**UPPER UWCHLAN TOWNSHIP
PLANNING COMMISSION
AGENDA
November 14, 2019**

I.	Call To Order	
II.	Profound Technology – Land Development Plan Review and discuss the consultants' comments regarding the land Development plan proposing a building addition to the existing Building. Review new architectural elevations.	2
III.	Starbucks – Eaglepointe Shopping Center Final Land Development Plan Review and discuss the consultants' comments regarding the proposed renovation of the former Key Bank drive-through in Eaglepointe Shopping Center for a Starbucks Coffee Shop.	15
IV.	DSM Biomedical – Eagleview Corporate Center Lot 2 -- Preliminary / Final Land Development Plan Review and discuss the consultants' comments regarding the addition of an @ 500 SF pre-manufactured building to be used for storage.	25

Reference: 125 Little Conestoga Road
Preliminary/Final Land Development Review
Upper Uwchlan Township, Chester County, PA

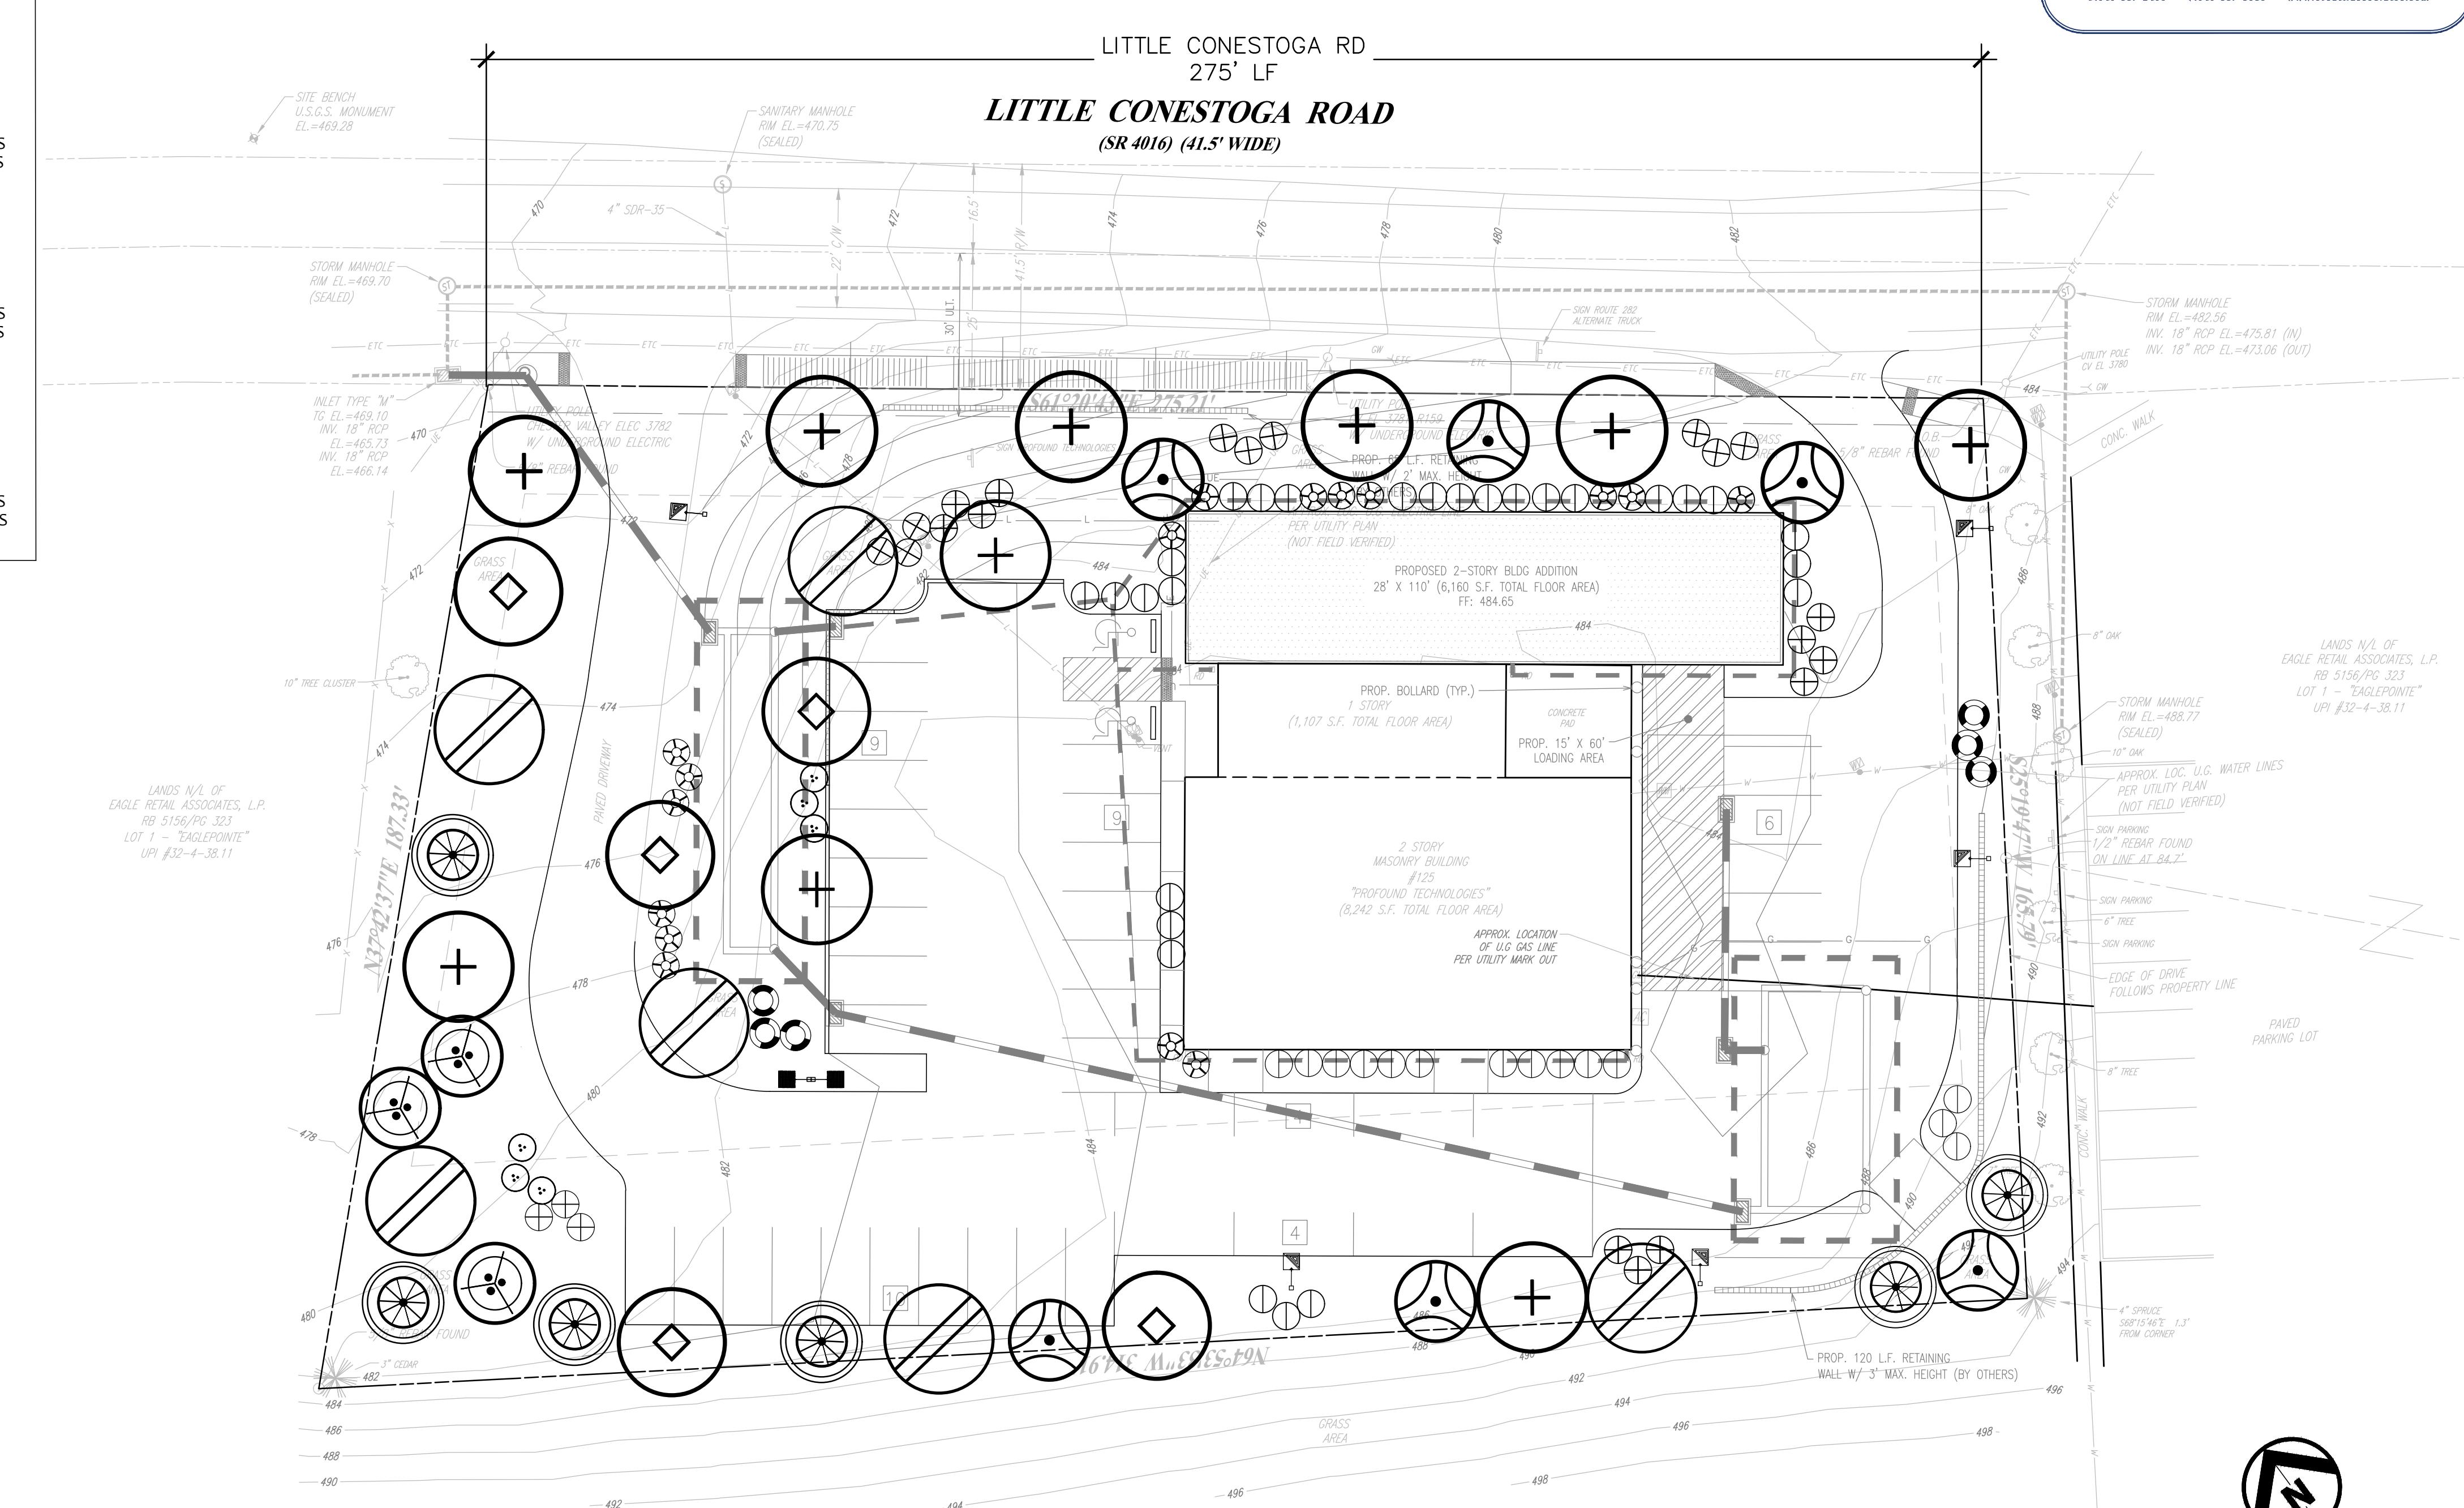
2. Landscaping – Overlooked on the past review is the proposed location of a Linden Plane and a Black Gum tree to the left and above the Type B5M-2 luminaire, which at maturity or before, are judged to provide significant blockage of the output of the Type B5M-2 luminaire assembly illuminating the paved driveway. **It is recommended Applicant be requested to take appropriate corrective action to resolve this light-blockage issue.**

Detail of the cover sheet of the plan

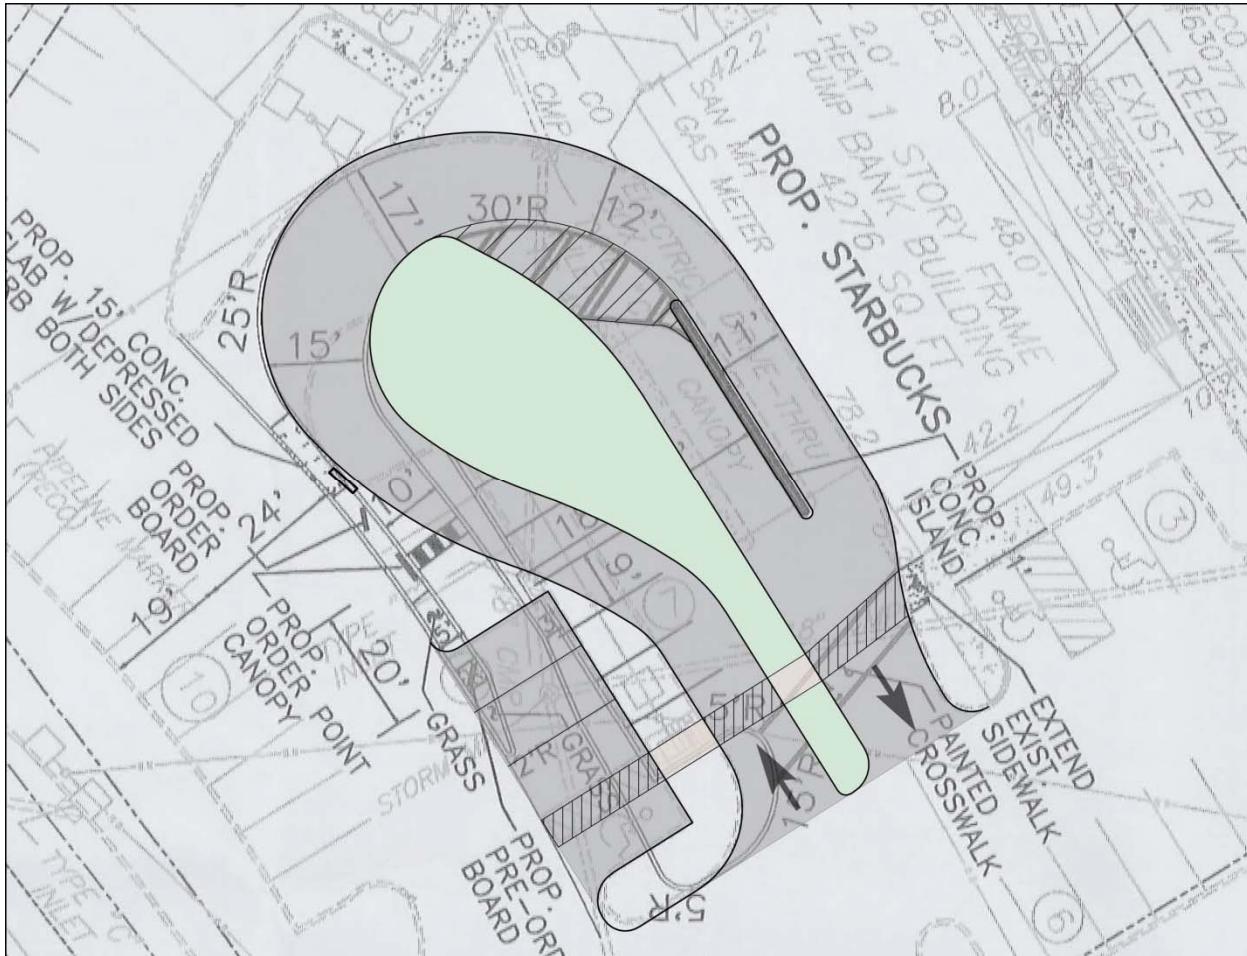
3. The plan indicates the applicant received conditional use approval on July 24, 2019. The Township should verify that all applicable conditions of approval have been incorporated into the final plan.
